AERONAUTICAL CHARTING MEETING
Charting Group
Meeting 22-01 – April 26 - 28, 2022

RECOMMENDATION DOCUMENT

FAA Control #22-01-369

Subject: Depiction of Wildlife, Seashore, and Other Non-Actionable Areas on IFR Charts

Pictured below is the Muscatatuck National Wildlife Refuge on the KOVO RNAV RWY 5 approach, followed by depiction on the VFR sectional.

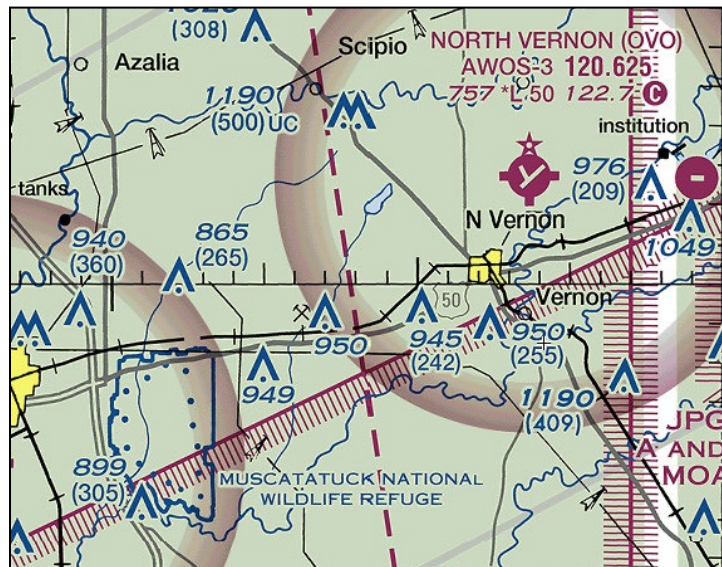
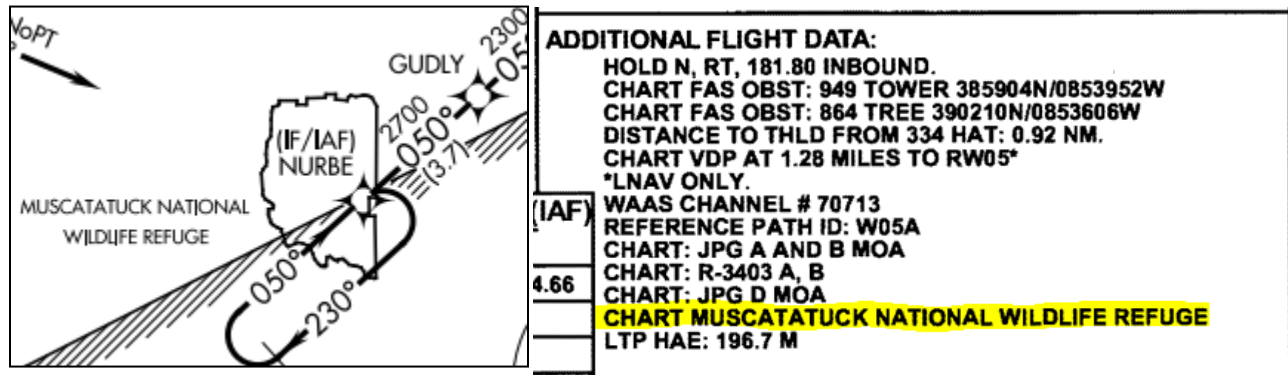
The purpose of charting these types of areas on IFR publications is unclear since they do not present a regulatory impact on pilots operating in the IFR system.

Garmin recommends against depiction of wildlife/seashore areas on IFR publications due to their lack of impact to IFR operations and negative affect by adding clutter to the chart. Where bird/wildlife activity is a significant hazard (see HSV), textual notes describing the hazard seem sufficient. In all other cases, these areas ought not to be shown on any IFR charts.

In March 2022, Bill Tuccio from Garmin called an anonymous DPE operating near KOVO and asked about the Muscatatuck National Wildlife Refuge; he found it so irrelevant he never asked about it on an IFR checkride and expected applicants to dutifully ignore the wildlife refuge during an instrument approach (Tuccio paraphrase of conversation, any errors thereof are Tuccio's own).

Pictured below is the Wheeler National Wildlife Refuge on the KHSV RNAV Runway 36R approach, followed by depiction on the VFR sectional

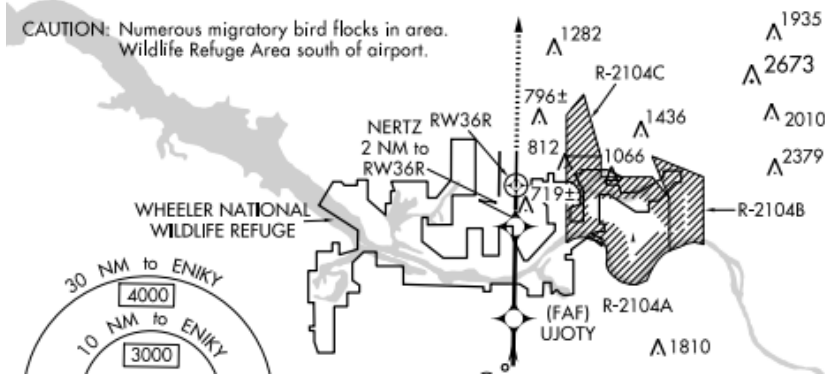
CHART NOTE: ASR
 CHART CIRCLING ICON.
 CHART R2104A, R2104B, R2104C
 CHART WHEELER NATIONAL WILDLIFE REFUGE
 CHART VDP AT 1.00 NM TO RW36R*
 *LNAV ONLY

For pilots operating under IFR on published procedures the purpose of depicting these wildlife areas is much less clear. Altitude compliance is recommended in the best case, and TERPS procedure design should account for overflight of these areas. The KHSV case includes a migratory waterfowl note, but most similar cases do not.
